Access Compliance Report

Public Rights-of-Way

(Curb Ramps)

Intersection ID: 3579	Main Street: KENT_VILLAGE_DR	Cross Street: SAXONBURY_WY	Location: E
ADA ID: 67C041B53B4D	Ramp Type: Perp	Initial Pass/Fail: Fail	Overall Compliance: No
Codes/Mitigation Info/Possible Solution		Field Measurements/Component Compliance

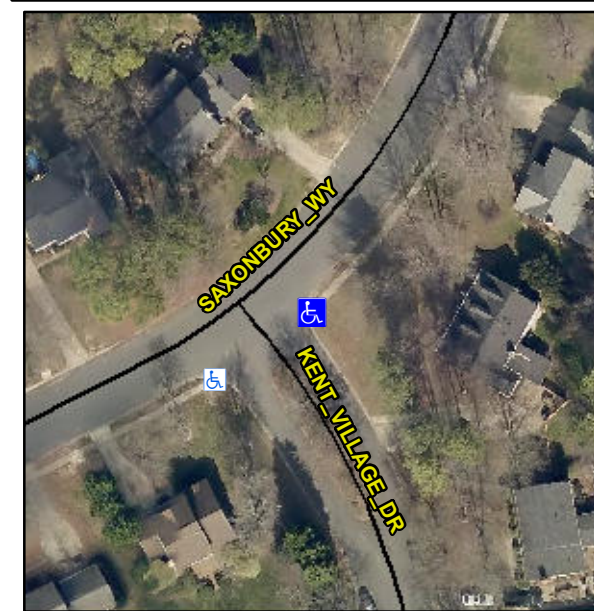
Not Found, R304.5.1, R304.2.2

Compliance	Description	Data	Compliance	Description	Data
N/A	Ramp Length (in)	52.5	No	Ramp Slope (%)	8.4
No	Ramp Width (in)	47.5	Yes	Ramp XSlope (%)	0.8
N/A	Flare Type LT	N/A	N/A	Flare Type RT	N/A
N/A	Flare Slope LT (%)	N/A	N/A	Flare Slope RT (%)	N/A
N/A	Flare Traversable LT?	N/A	N/A	Flare Traversable RT?	N/A
N/A	Landing Length (in)	N/A	N/A	DWS Provided?	N/A
N/A	Landing Width (in)	N/A	N/A	DWS Contrast?	N/A
N/A	Landing Slope (%)	N/A	N/A	DWS Length (in)	N/A
N/A	Landing X Slope (%)	N/A	N/A	DWS Full Width?	N/A
N/A	Landing Curb? (Y/N)	N/A	N/A	DWS Offset (in)	N/A
N/A	Shared Landing?	N/A			
N/A	Gutter Ponding?	N/A	N/A	Gutter Slope (%)	N/A
N/A	Gutter Lip Ht (in)	N/A	N/A	Gutter X Slope (%)	N/A
N/A	Painted X Walk1?	No	N/A	Painted X Walk2?	N/A
	X Walk 1 Direction	To SW		X Walk 2 Direction	N/A
N/A	X Walk 1 Width (in)	N/A	N/A	X Walk 2 Width (in)	N/A
	X Walk 1 Slope (%)	1.5		X Walk 2 Slope (%)	N/A
	X Walk 1 X Slope (%)	1.1		X Walk 2 X Slope (%)	N/A

Remove & Replace Entire Ramp.
